Purpose

► To issue a Development Permit for the form and character of an apartment housing development.

- ► Development Permit for a four-storey apartment housing development.
 - > 20 units in total
 - ▶ 3 1-bed
 - ▶ 14 2-bed
 - ▶ 2 3-bed
 - ▶ 1 4-bed townhouse
 - ▶ 26 parking stalls

Landscape Plan

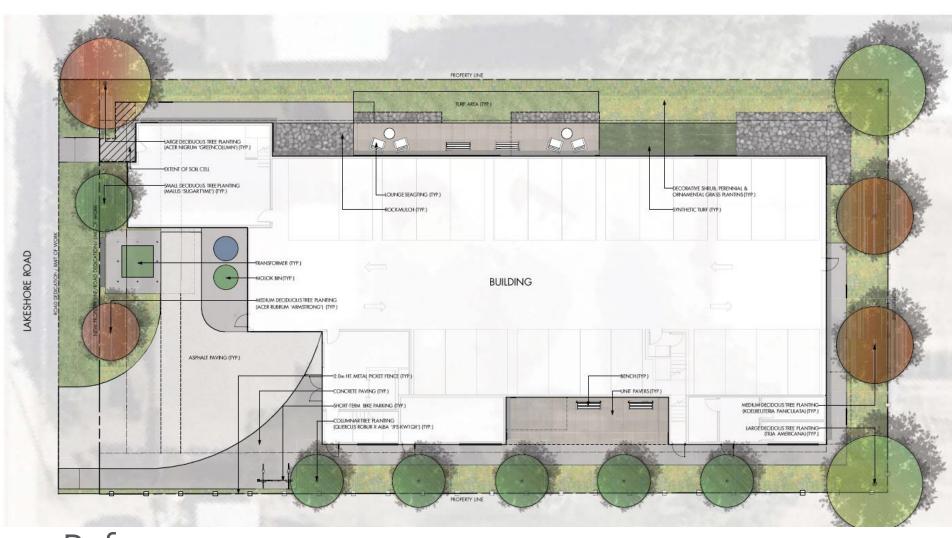
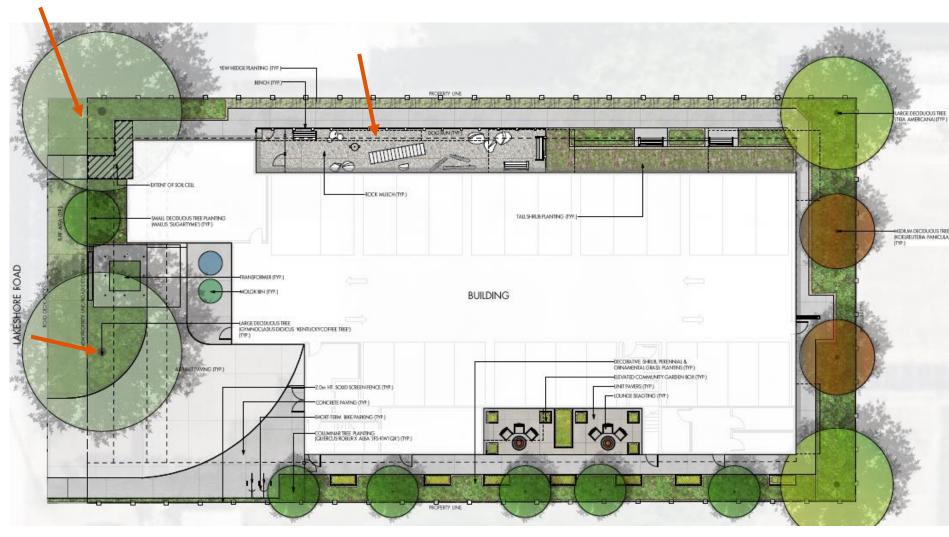
- Additional features to sides that face neighbouring properties:
 - Extending wood slat to all sides;
 - Additional buildouts to articulate and frame balconies;
- Amenity spaces further programmed;
 - Additional of dog run and benches to the north amenity space;
 - Addition of seating around and fire pits at south;
- Improved landscaping along Lakeshore with the addition of larger trees.
